Date: Thursday, 05 March, 2020 20:20
Subject: RE: FW: Kingspark 17/00765/FULL - Flood Risk and Drainage Related Comments

I can confirm that Dundee City Council are satisfied that surface water runoff from the development can discharge to the Gelly Burn at the discharge rates below. This is on the basis that the post-development surface water discharge rate to the Gelly Burn culvert is no greater than the pre-development discharge to the culvert, as demonstrated by the submitted Millard "Drainage Statement: Kingspark - Justification of Attenuated Surface Water Discharge Rate" Revision B:

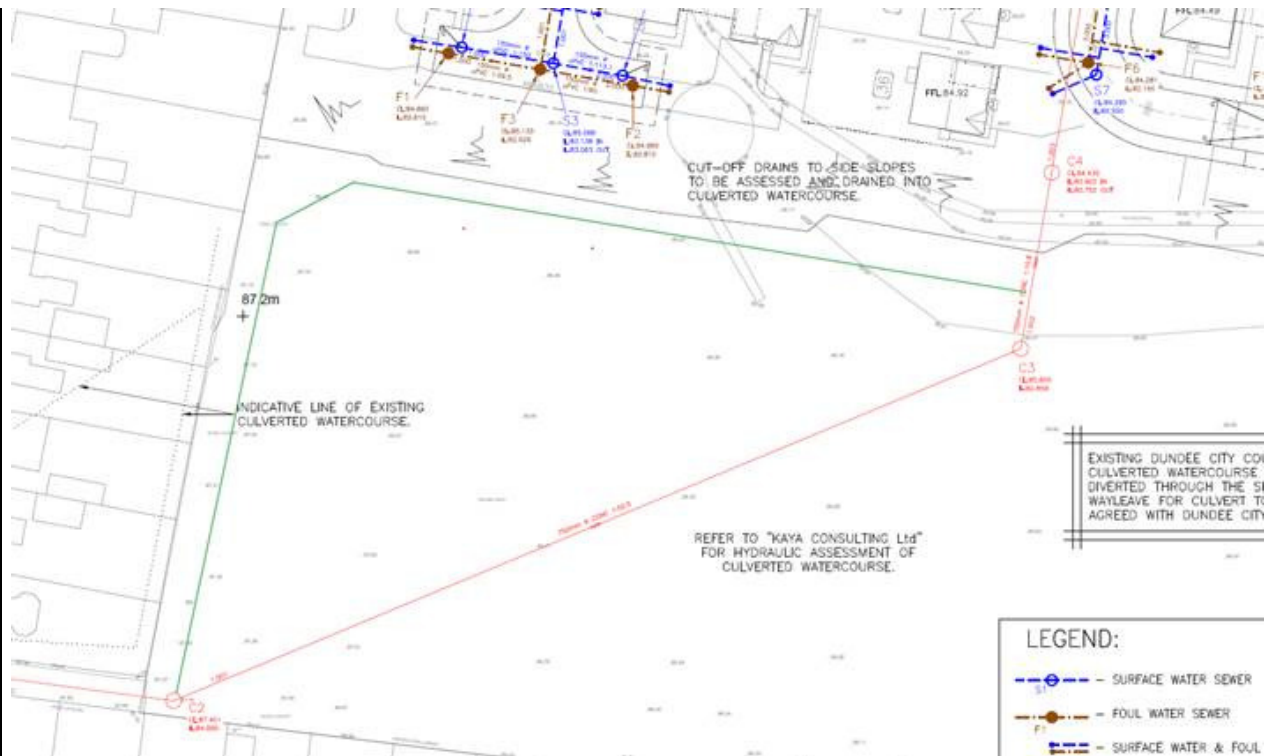
9. Proposed ownership/maintenance responsibilities of/for the proposed drain/culvert bypass sewer to be clarified and a Maintenance Schedule submitted.

■ – As above, agreed this will be owned / maintained by factor. Evidence to be submitted.

AR 27/1/2020 - The letter dated 6/1/2020 from SGPM confirms that they will be incorporate the maintenance of the culvert (within the development site) into the "Factoring Responsibility". Completed DCC Future Maintenance Certificate (confirming who is legally responsible for maintenance of the culvert/proposed drain/culvert bypass sewer within the development site) and associated drawing and maintenance schedule for the culvert to be submitted. Ownership of the proposed drain/culvert bypass sewer within the development site must also be clarified on a drawing. If ownership of the culvert/proposed drain/culvert bypass sewer within the development site is to be split between the property owners then this must be included in the property title deeds/missives. - Condition 8.
